SK-RFI3447R00-E337D

DETAILS
SCADA REMOTE TERMINAL UNIT SYSTEM
#TEL-5 TERMINAL CONNECTION DIAGRAM

SK-RFI3447R00-E383

DETAILS
STRONG MOTION DETECTION SYSTEM CABLE BLOCK DIAGRAM

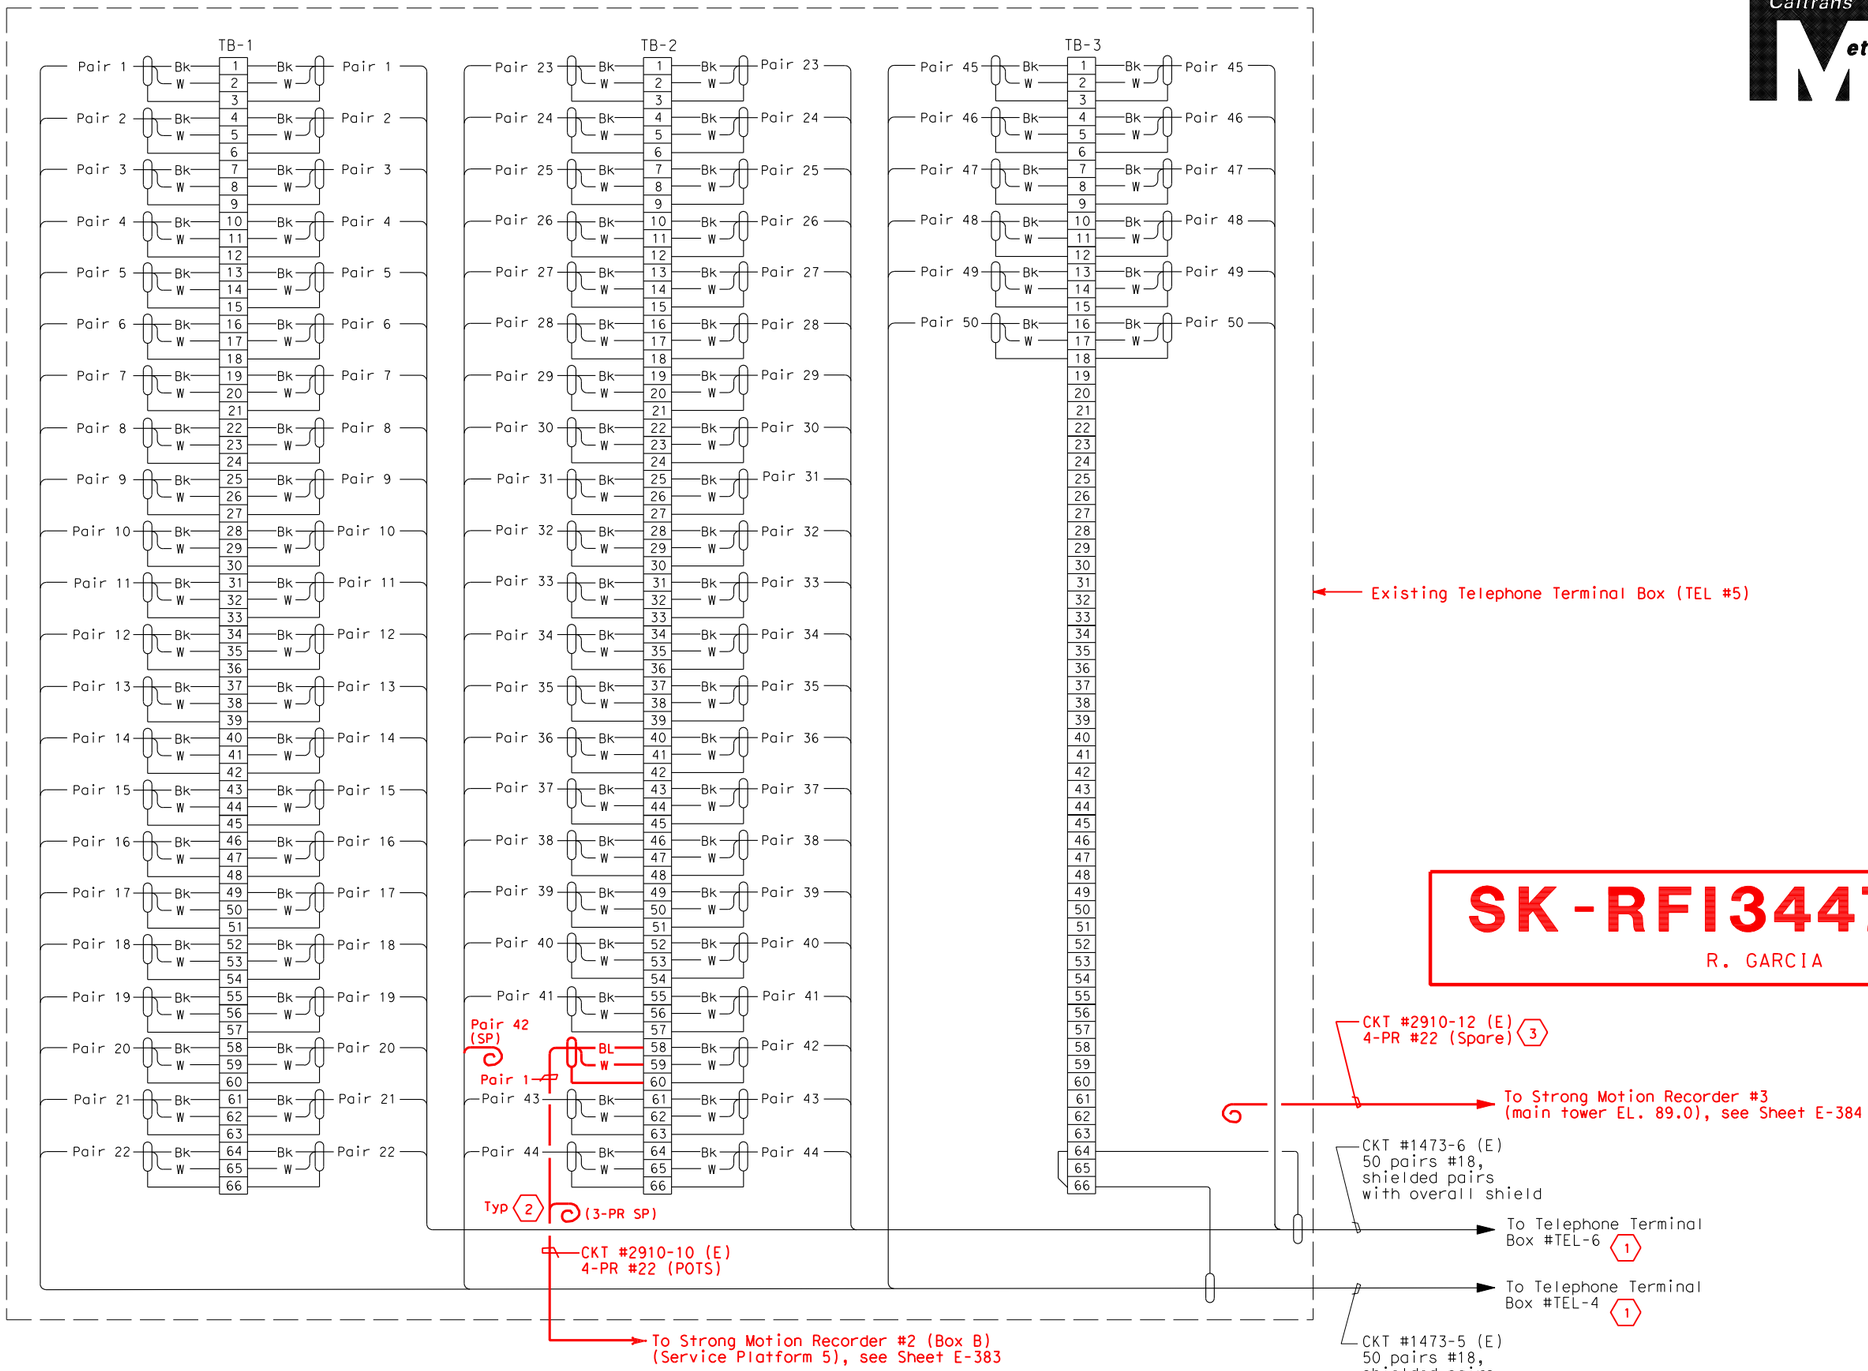
1. For terminal connection diagram and continuation to TEL #4, see E-337C. For TEL #6, see E-337.
2. Spare cable or conductor ends shall be coiled and taped.
3. Existing cable #2910-12 shall be abandoned in place, labeled spare and unterminated. Cable ends shall be coiled and taped.

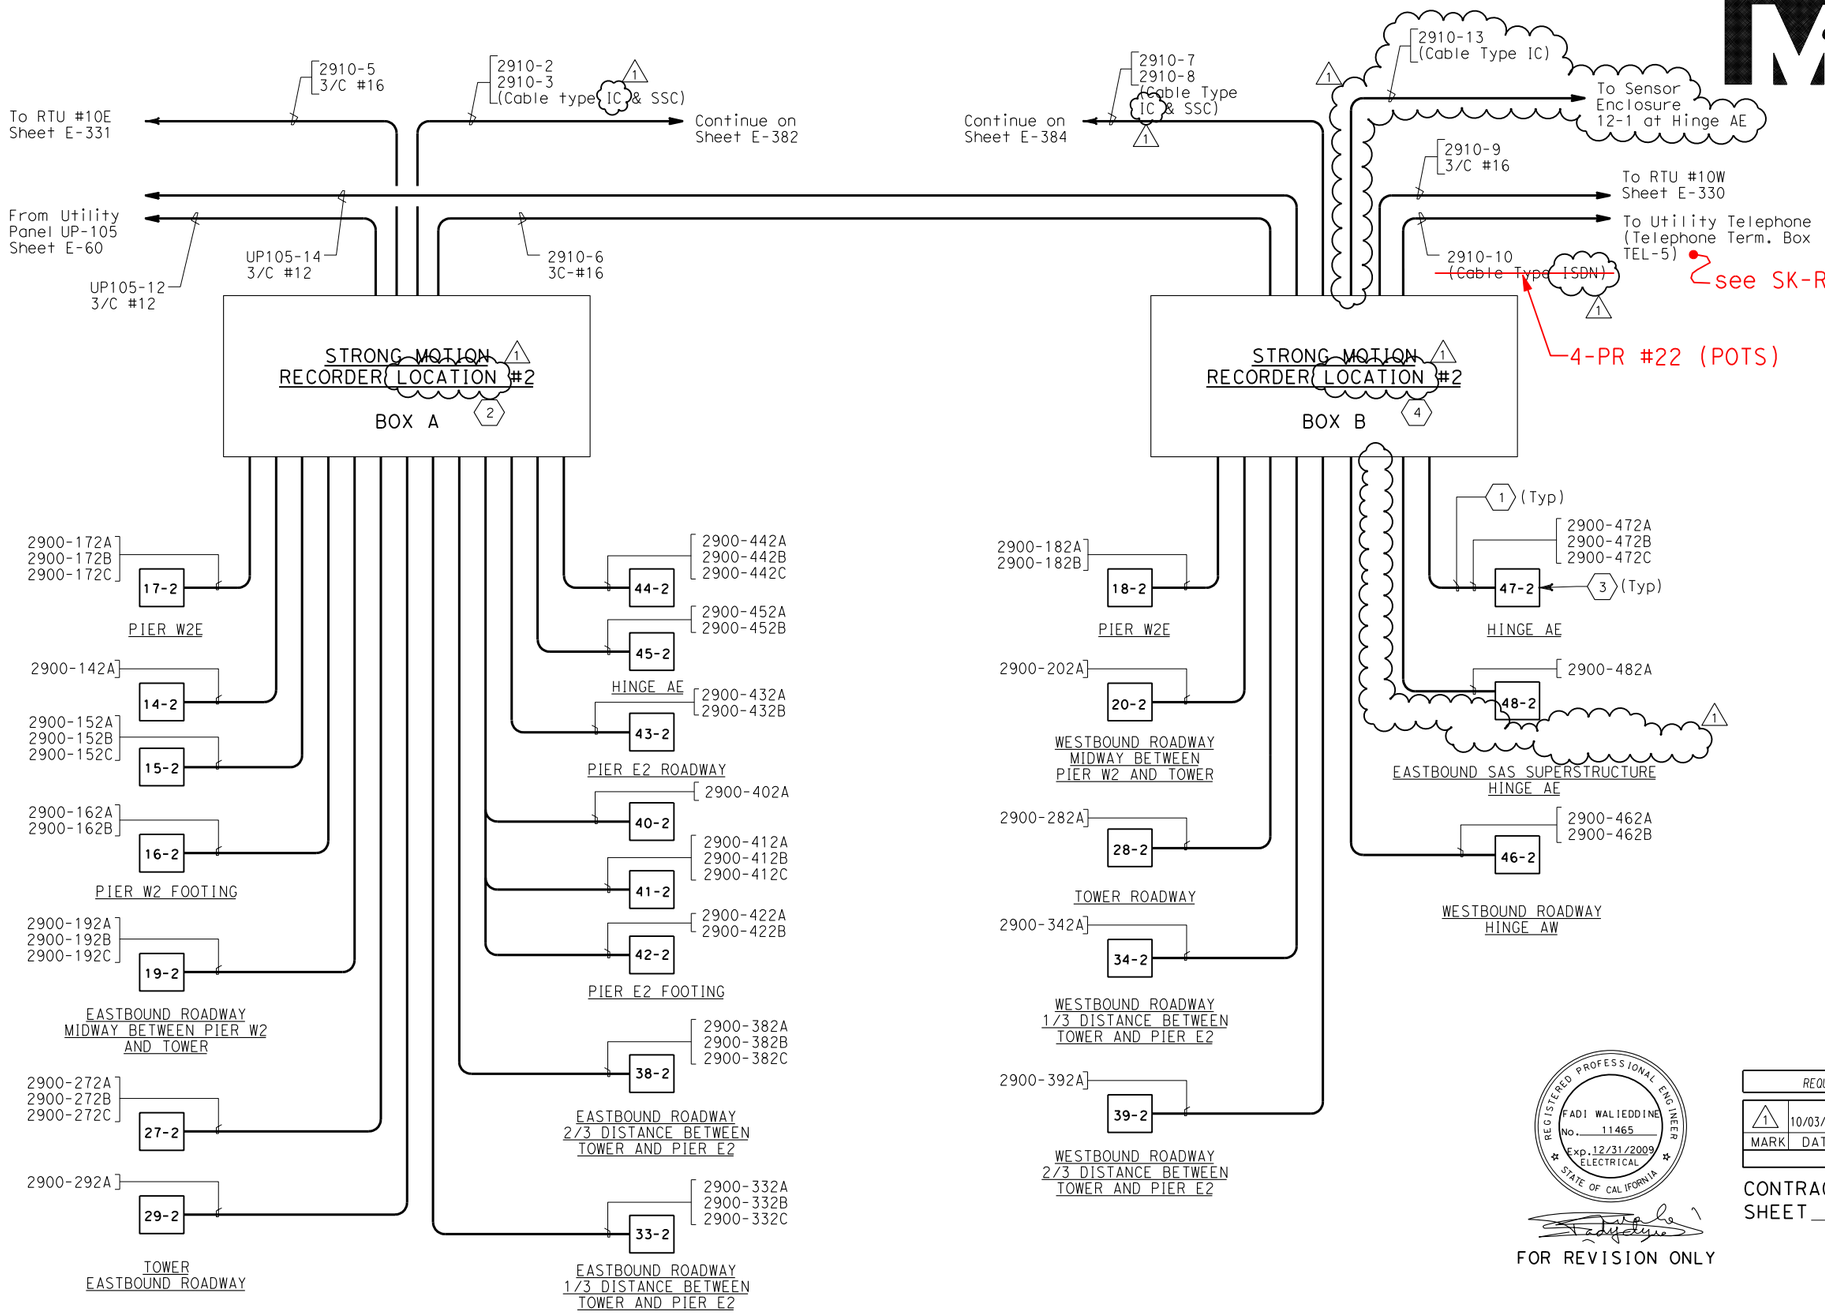
1. Strong Motion sensor cable Type SSC, unless otherwise indicated.
2. Strong Motion Recorder #2 Box A consists of two 18-channel recorders and one 12-channel recorder, connected to a total of 35 sensors.
3. Sensor enclosure with identification number as shown.
4. Strong Motion Recorder #2 Box B consist of one 18-channel recoder connected to a total of 12 sensors.

DETAILS
STRONG MOTION DETECTION SYSTEM CABLE BLOCK DIAGRAM
NO SCALE

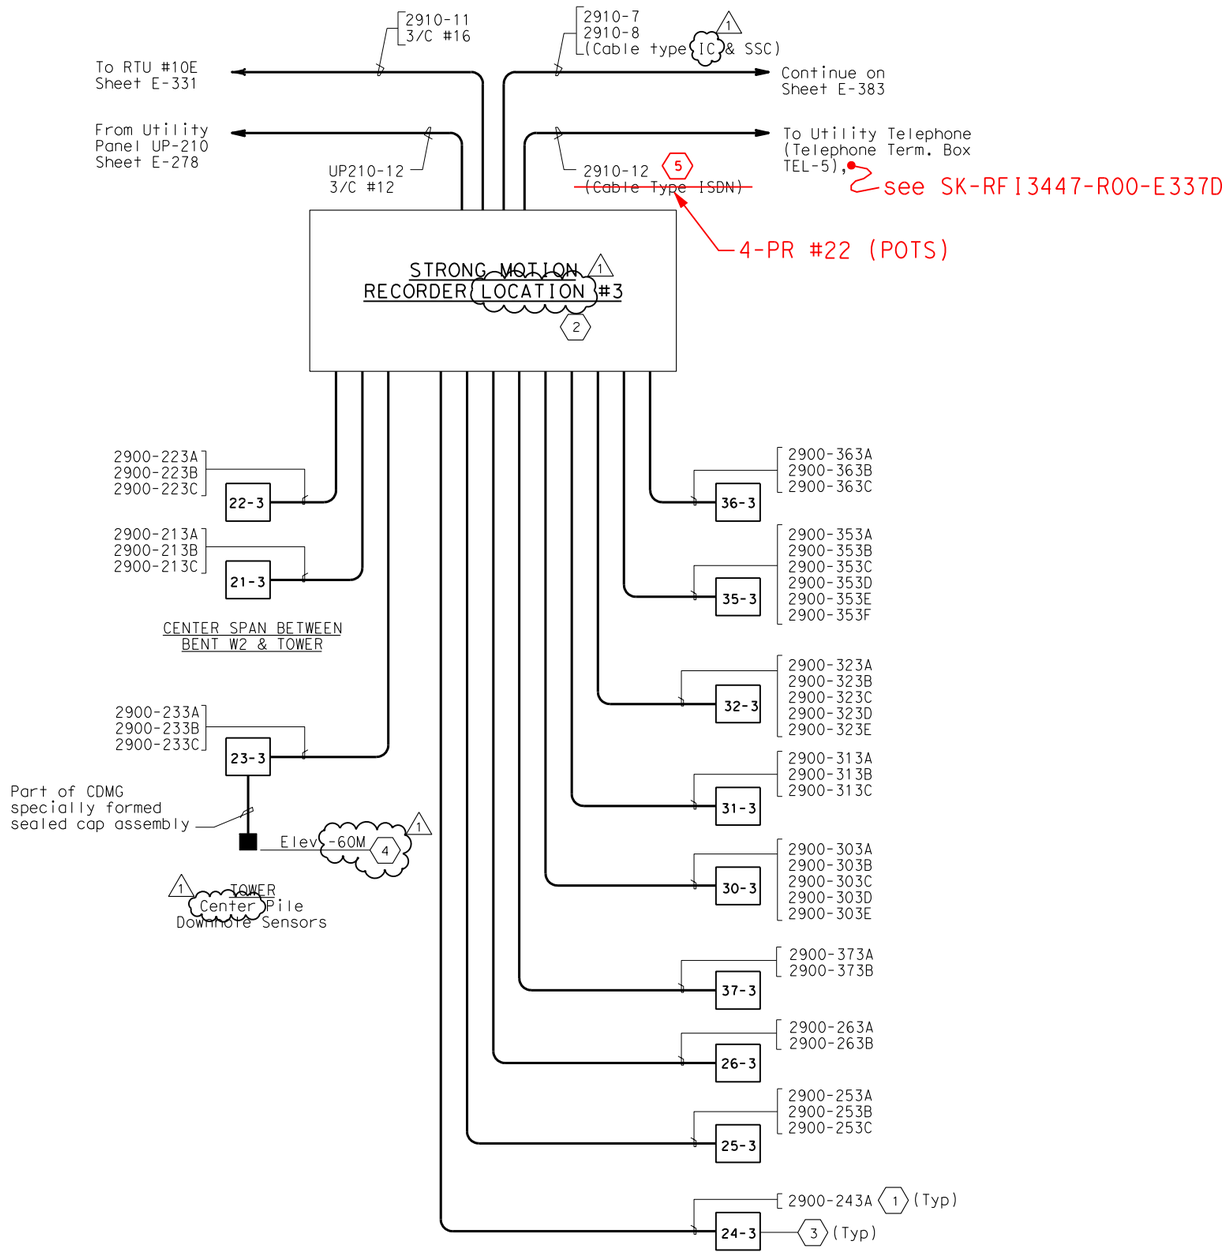
1. Strong Motion sensor cable Type SSC, unless otherwise indicated.
2. Strong Motion Recorder #3 consists of one 18-channel recorder and two 12-channel recorders, connected to a total of 39 sensors.
3. Sensor enclosure with identification number as shown.
4. Sensor enclosure 23-3 at tower elevation 3M. Sensor orientation assembly at minus 60M. Installation of downhole sensor package and associated cabling by others.
5. Existing cable #2910-12 shall be abandoned in place, labeled spare and unterminated. Cable ends shall be coiled and taped.
